northwest hydraulic consultants

MEMORANDUM

TO:	Andrew Gower, P.Eng. Wedler Engineering	DATE:	January 5, 2015
FROM:	Dave Mclean (NHC)	NO. PAGES:	4
CC:		PROJECT NO.:	3000276
		REF. NO.:	
RE:	Lazo Road Erosion Bank Protection NHC Comments on Preliminary Design

STATION 1+190 TO 1+390

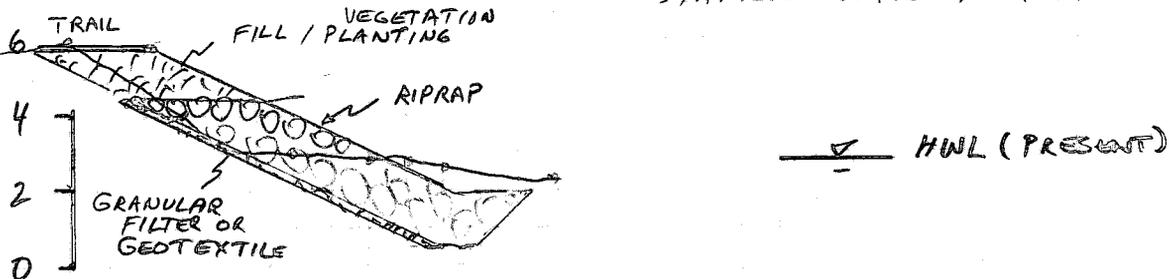
In NHC's November 17 report we indicated either riprap or anchored LWD could be used for protecting higher elevation sections of the shoreline (between elevation 3.2 m to 4.4 m Canadian Geodetic Datum). In sections between 1+190 to 1+380 and between 1+570 to 1+700 there is not sufficient room to install both the LWD and the riprap revetment. In these sections, the LWD can be eliminated and the riprap revetment should be extended higher to prevent erosion from wave uprush. Proposed crest levels for the riprap revetment are shown in Table 1; these are between 0.4 m to 1.0 m higher than the levels shown on the draft plans.

Suggested conceptual layouts of the riprap protection are shown on the attached sketches. These layouts are based solely on coastal engineering considerations at the site. An example of an LWD revetment has also been attached to illustrate the concept of using anchored LWD as an erosion control measure. The concepts may need to be revised to account for other planning and environmental factors at the project side and have been provided to help further refine the planning process. The concepts are not intended as final designs of the erosion protection.

Station	Top of Riprap Revetment (m CGD)	LWD Revetment
1+020 to 1+190	3.8	2 rows of LWD with riprap ballast
1+190 to 1+390	4.4	None
1+390 to 1+490	None	2 rows of LWD with riprap ballast
1+490 to 1+570	4.4	Intermittent, 2 rows of LWD with riprap ballast
1+570 to 1+700	4.0 (top of bank)	None

STATION 1+570 TO 1+700

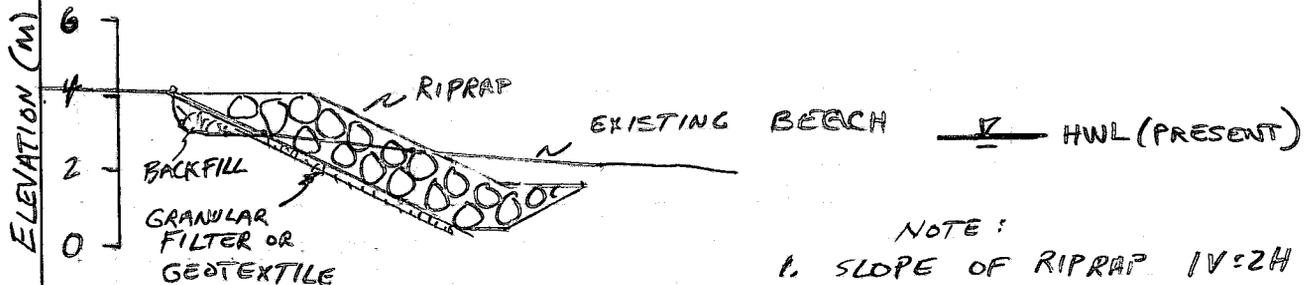
The height of the wave runup (2% exceedence) was estimated to be 4.0 m for the December storm, causing significant overtopping along the northern section of the road between Station 1+580 to 1+700. The video imagery from the December storm showed spray and overtopping did occur along this section, which confirms the analysis. During more severe storms, general overtopping will occur in this section. For the 200 year storm condition, the maximum wave runup (2% exceedence) was estimated to range from 0.9 m (using the van Rijn equation) to 1.8 m (using methods in EM 1110-2-1100²). The corresponding maximum runup elevation ranges from 4.7 m to 5.6 m (Geodetic datum) for the future sea level rise scenario that was adopted in our wave climate study. Therefore, providing drainage control for the swash and spray will be a significant issue along this section of the road.
